MEMORANDUM

Re: Slope Instability - Hwy 17 (approximately
0.5 km west of Regional Rd. 35)
Twp of Cumberland
W.P. 502-93-00
District 9, Ottawa

RE: Shoulder & Slope Failures at Sta 19+475, Twp of Cumberland.
WP 502-93-00, Hwy. 17 From Reg Rd # 37 to Rockland, Dist 9, Ottawa

Figure 8

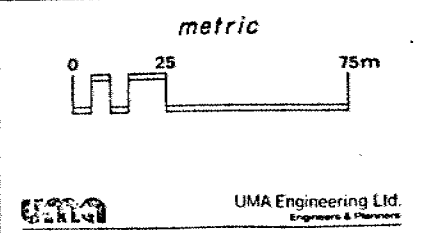
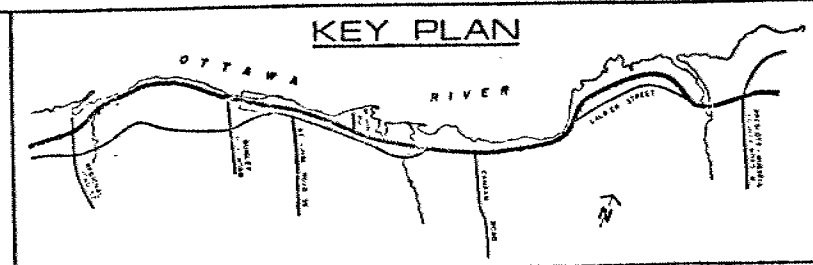
Sta. 19+300± to 19+600± (South Side) *AND Comments May 7*

- although all the widening in this area is concentrated to the south side of the existing highway and away from the river, there is a very deep fill over a large culvert. Planning and Design is concerned with the slope stability in this area.

Failure at North Shoulder Hwy 17
Sta 19+475
Twp Gloucester

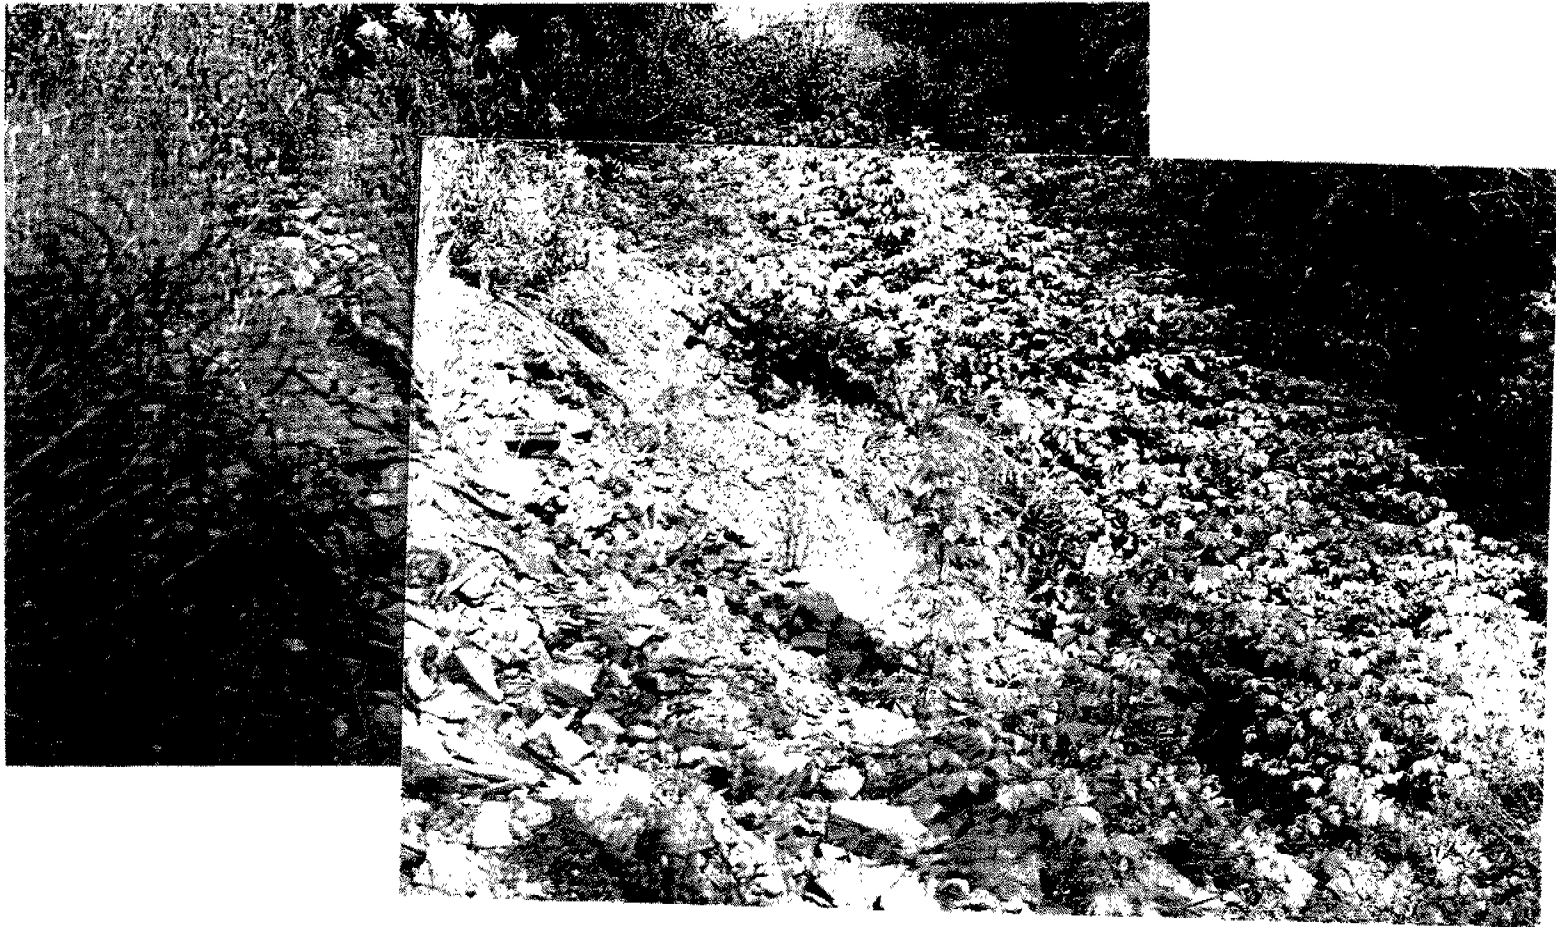
- i) The shoulder failure involves a surficial slippage of wet clays over the moist underlying clays in the 6m - 8m fill. (see photos taken August 17/94)
- ii) Photos taken Sept7/94 indicate that the shoulder slippage has progressed slightly since the initial investigation on August 17/94.
- iii) The lower portion of the slope below the shoulder slippage is treed, with a small water course at the 30m ROW limit. The private property here appears to be well maintained (Mown & Treed).
- iv) Stabilisation treatment will be complicated by the treed slope, the height and steepness of the slope, the watercourse at the base, and the slippage underway.

- (1) Remove surficial sliding mass. The thickness of the sliding mass is estimated as 0.3 to 0.5 m. The existing tree cover and roots present within the lower stable portion of the slope shall not be disturbed.
- (2) Replace the excavated material with 600 mm rockfill placed at 1.25H:1V or flatter. The rockfill shall be rip rap or gabion stone as specified in OPSS 1004.5.06.01.
